Reference: planning application 253071

**RESPONSE TO PLANNING APPLICATION 253071, LAND TO THE WEST OF PARK LANE,
CHARVIL, RG10 9TS**

Response to Reserved Matters Application 253071 on behalf of residents of 8, 11, 12, 22 – 26 on Canberra Lake Way, Charvil.

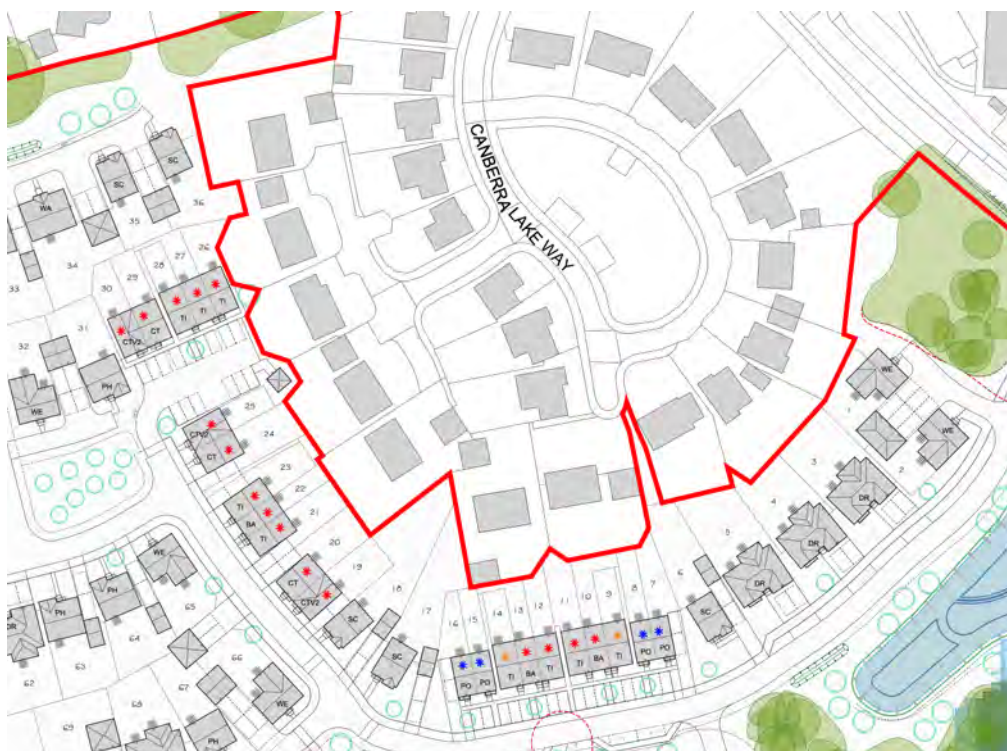
17. **Indicative Site Layout** – The boundary of outline planning application 232704, for up to 75 dwellings, overlapped the boundary of the planning consent for Canberra Lake Way (143292). As stated above, the consented landscaping scheme for 143292 was not implemented where this overlap occurred, but was in all other respects. The submitted indicative layout had some regard to the landscaping buffer to the rear of properties on Canberra Lake Way through its retention, except where this was removed behind nos. 8 to 10 Canberra Lake Way and the removal of some buffer behind no.22. This is shown on an extract from the indicative site layout below.

18. **Commitment to safeguard the privacy of existing dwellings** – The applicant's submitted Site Analysis Plan DWG.102 showed that the privacy of existing adjoining dwellings on Canberra Lake Way and the Hawthorns would be safeguarded through the incorporation of buffers and the development mid-density dwellings in these areas. These are shown on an extract of the plan below.

23. **Comments** – The Outline Planning Application 232704 makes a clear commitment to provide the landscape scheme similar to that consented and partly implemented under permission 143292. The commitment is explicit in seeking to safeguard the privacy of existing dwellings on Canberra Lake Way. Landscape Officer comments on the planning application proposal suggest the need to provide a different solution to address security issues. Condition 31 is applied in the decision notice in order to protect the privacy of adjoining and future occupiers in accordance with Policy CP3 and CP7. There is a clear requirement for Reserved Matters to set detailed site layout proposals such that a landscaping scheme can satisfy this requirement.

24. Residents of Canberra Lake Way request that the landscape buffer is provided as proposed in 232704 and security issues are addressed through the creation of gated access to the area.
